DEPARTMENT OF DEVELOPMENT SERVICES – PLANNING DIVISION
REPORT: 410 Homestead Variance for consideration May 4, 2021

STAFF REPORT

PROJECT: Blue Hills Civic Association
410 Homestead Avenue
PARCEL ID: 152-190-018
P&Z-COMM-2021-0339

TYPE: Variances to: expand a nonconforming structure per Zoning Regulations 1.5.4.E; and, to move a characteristic of a nonconforming use to another location on the property per Zoning Regulations Section 1.5.3.E.

Figure 1. Site Layout Plan – Freeman Companies 2021

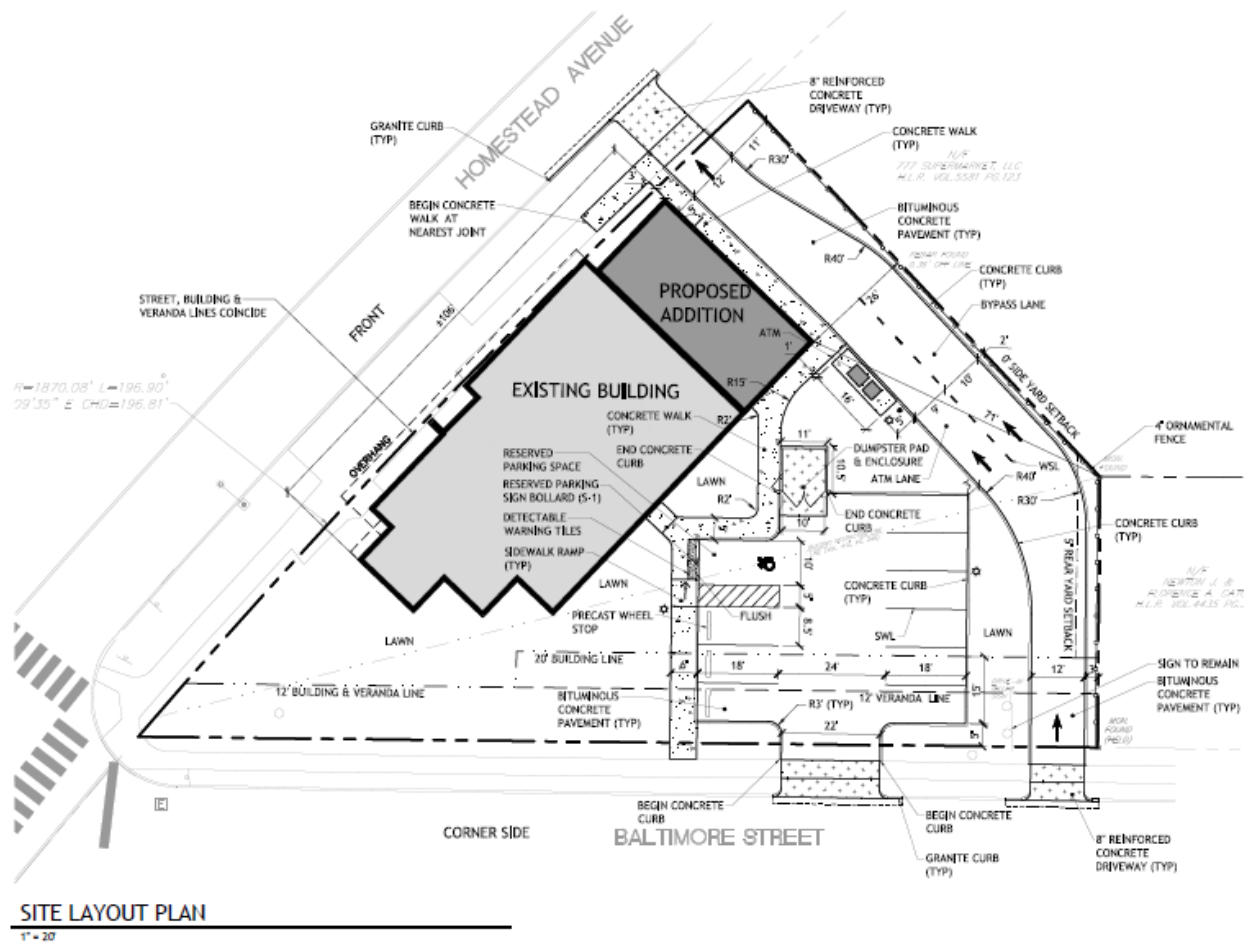
The proposed addition will constitute an expansion of a nonconforming building in that the addition will be at the same nonconforming height and the added footprint will not eliminate all nonconforming characteristics such as the occupation of the corner or the corner build-to line requirement. However, the proposed addition does not create any new nonconformity, and reduces other existing nonconforming characteristics.

It should be noted that the height of the proposed addition, 15' 4", is exactly 15% percent less than 18'. This is notable because according Sec.4.5.2, Note 2, if the first story is 18' tall it can be counted as two stories and is therefore conforming. Staff is authorized to adjust maximum or minimum requirements by up to 15% to accommodate reuse of existing structures per Sec.1.3.3.C.(5). The use of such an adjustment would be warranted in this case and the addition should be considered conforming in regards to height.

Storefront building types in the MS-2 district are required to occupy a minimum of 85% of the front build-to line. The building currently occupies 47% of the building line and the proposed addition will bring that metric to 58%. In this way the proposed will reduce the amount of nonconformity.

The existing nonconforming drive-through facility is proposed to be moved to the interior of the site in the form of an ATM machine as part of the renovation. The ATM, will be relocated to a position on the existing drive aisle that is still accessible to vehicles. However, the relocation of the drive-through facility to the interior of the site represents a reduction in the presence of a nonconforming accessory use and its associated structures. The reduction in nonconformity is a sufficient justification of the variance request to Sec.1.5.3.E, to allow the nonconforming characteristic (the ATM) to be moved. The granting of this variance should not be unlimited however. The variance should be limited to the ATM in its proposed location. Staff recommends adding this as a condition of approval.

The proposed addition is currently shown to expand the footprint of the building to the north away from the corner. The Applicant could redesign the addition to expand the building to the south and in doing so meet the requirements of the Regulations regarding occupation of the corner and the corner build-to line. This redesign would accomplish a similar reduction in nonconformity, however, it would leave the existing nonconforming drive-through facility on the north side intact. The proposed addition to the north accomplishes a similar reduction in nonconformity and is therefore an equally desirable design compared to possible expansion to the south.

1. The variance to Sec.1.5.4.E be applicable only to the addition as shown on the provided site plan and that the site plan be attached to the resolution as Exhibit A.
2. The variance to Sec.1.5.3.E be applicable only to the ATM in it's proposed location on the site plan, attached to the resolution as Exhibit A.
